ND-16-0252  
10 CFR 50.90  
10 CFR 52.63

Southern Nuclear Operating Company  
Vogtle Electric Generating Plant Units 3 and 4  
Request for License Amendment and Exemption:  
Relocation of Air Cooled Chiller Pump 3, VWS-MP-03 (LAR-15-018)

**Relocation of Air Cooled Chiller Pump 3, VWS-MP-03**

**Proposed Changes to the Licensing Basis Documents  
(LAR-15-018)**

**UFSAR Section 9.2, Figure 9.2.7-1 (Sheet 1 of 4), Simplified Central Chilled Water System Piping and Instrumentation Diagram (REF) VWS 006**

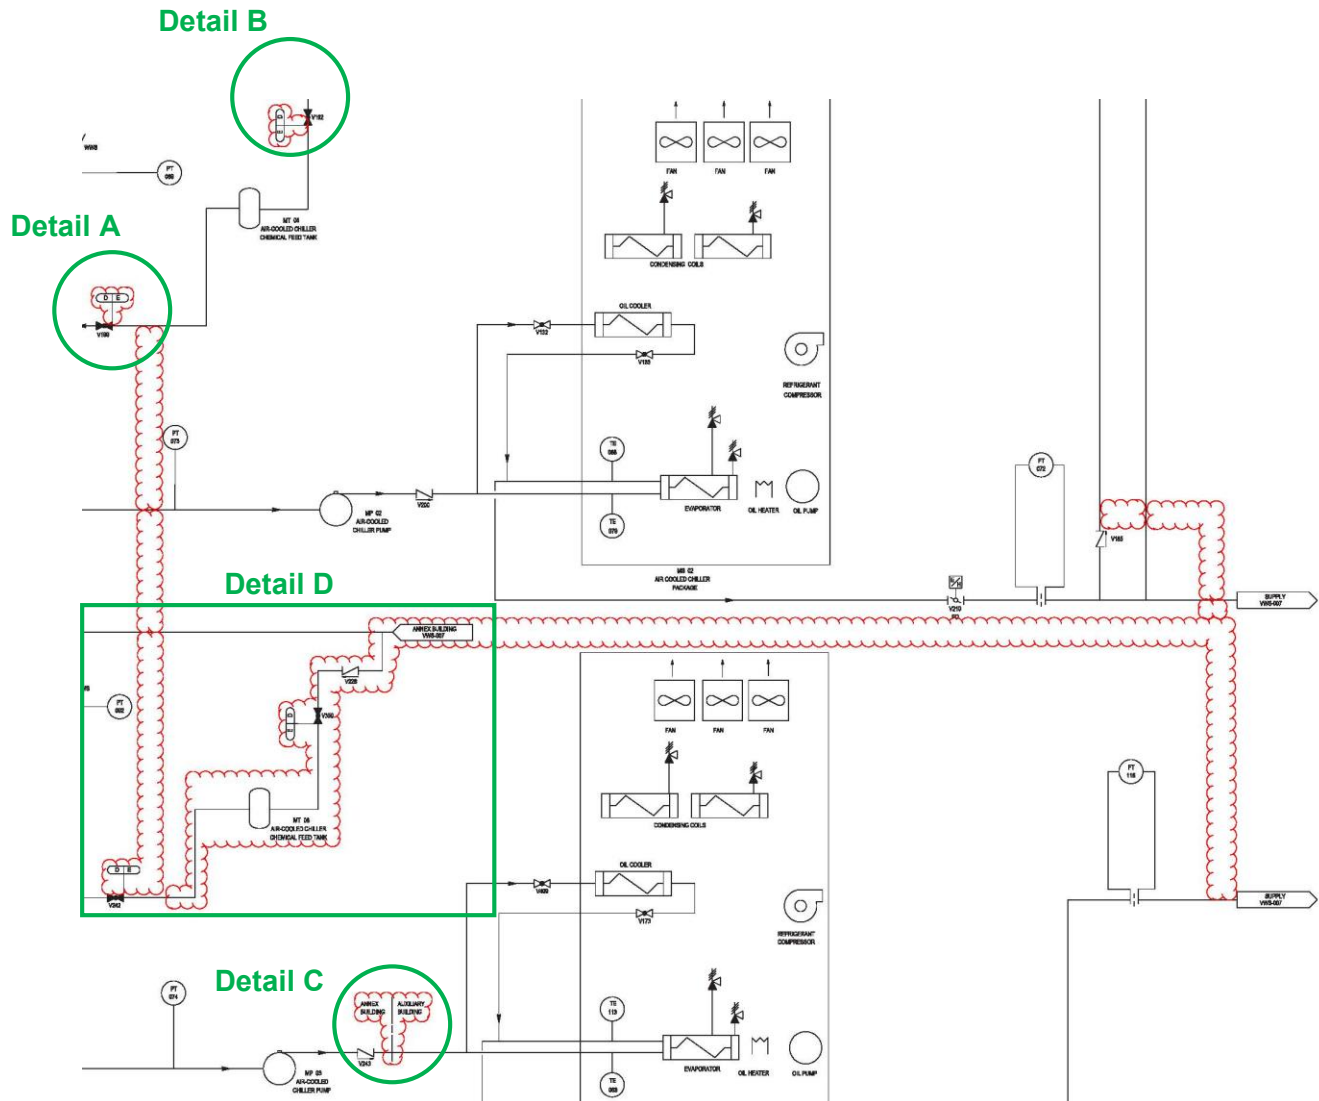
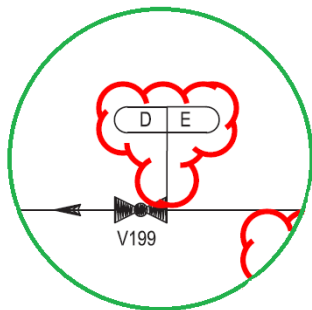
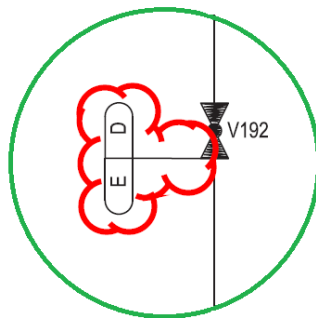
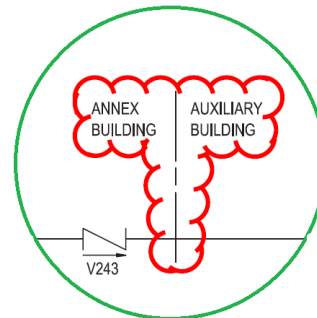
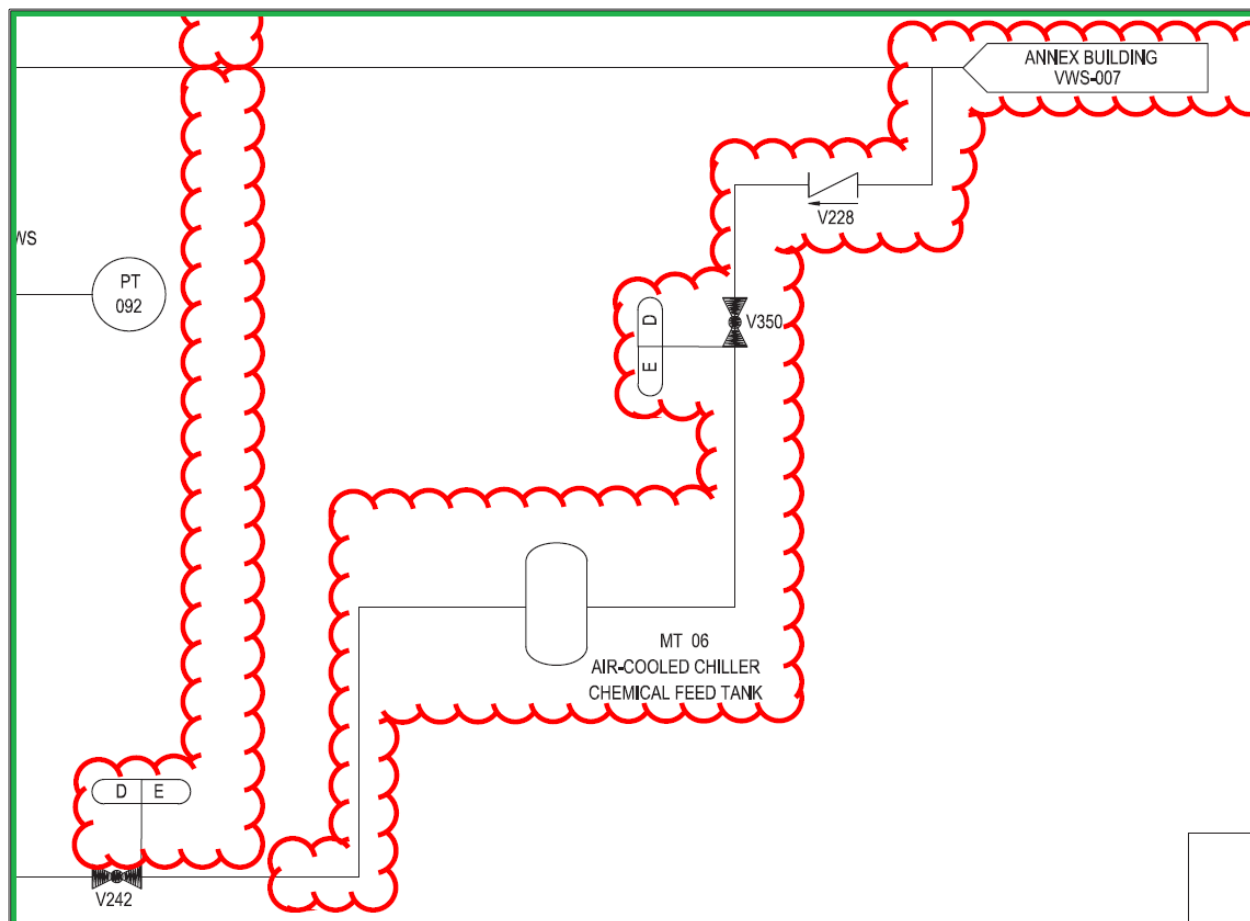
- Revise Figure 9.2.7-1 (Sheets 1 and 2 of 4) to:
  - Indicate that pump VWS-MP-03 and its associated equipment are located in the Annex Building.
  - Depict the revised configuration of the equipment associated with the relocation of the expansion tank and the new chemical feed tank, valves, and piping associated with VWS-MP-03.

Revise the title block of UFSAR Tier 2 Figure 9.2.7-1 (Sheet 1 of 4), as follows:

~~Inside Auxiliary Building~~  
Figure 9.2.7-1 (Sheet 1 of 4)  
Simplified Central Chilled Water System  
Piping and Instrumentation Diagram  
(REF) VWS 006

Revise UFSAR Tier 2 Figure 9.2.7-1 (Sheet 1 of 4), as depicted below (See detailed blow-ups below):

**UFSAR Section 9.2, Figure 9.2.7-1 (Sheet 2 of 4), Simplified Central Chilled Water System Piping and Instrumentation Diagram (REF) VWS 006**

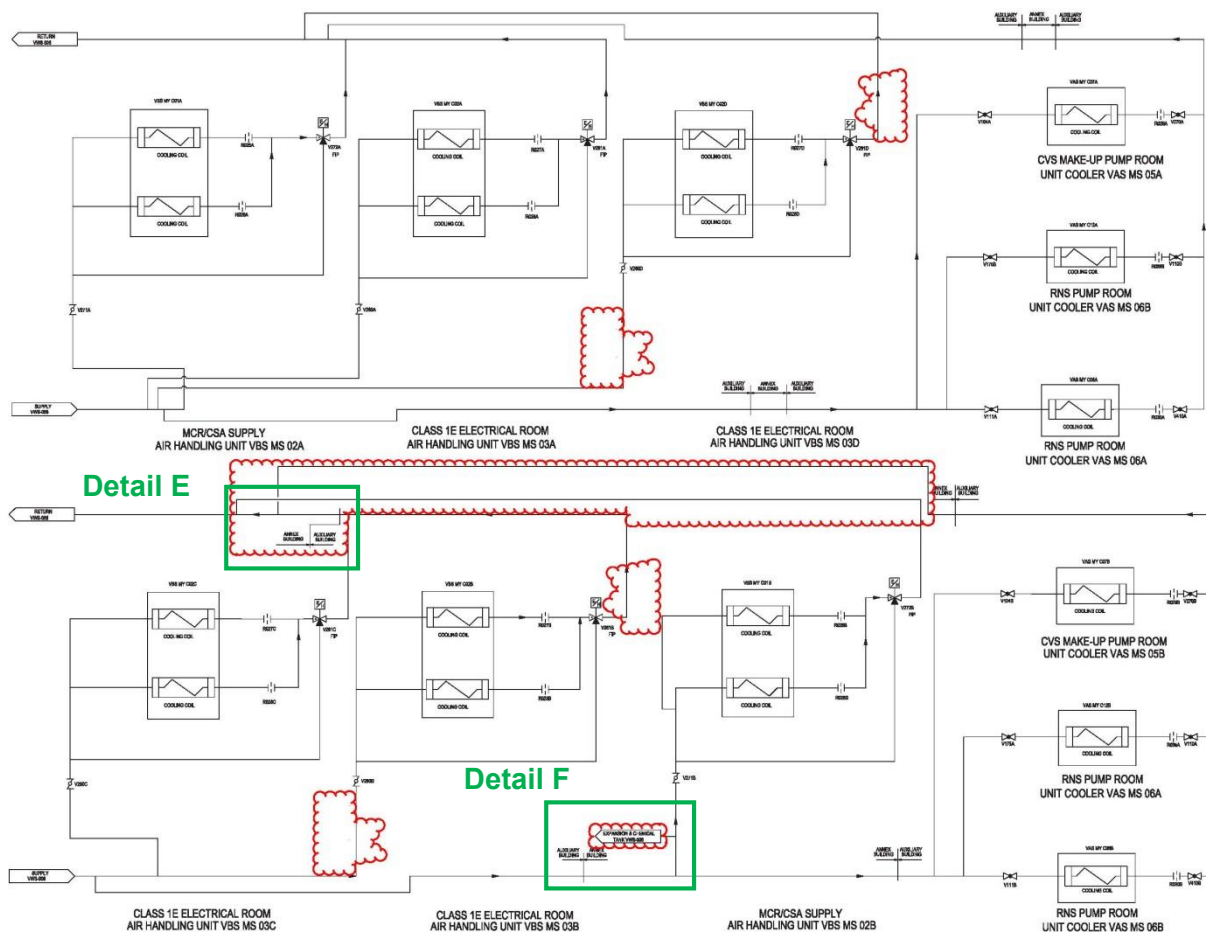
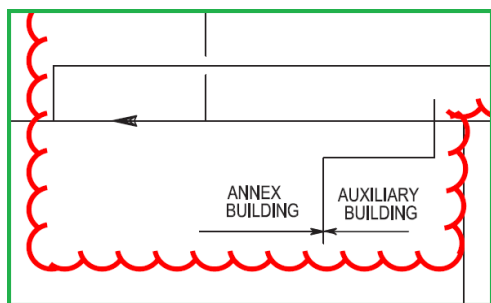
Revise UFSAR Tier 2 Figure 9.2.7-1 (Sheet 2 of 4), as depicted below (See detailed blow-ups below):
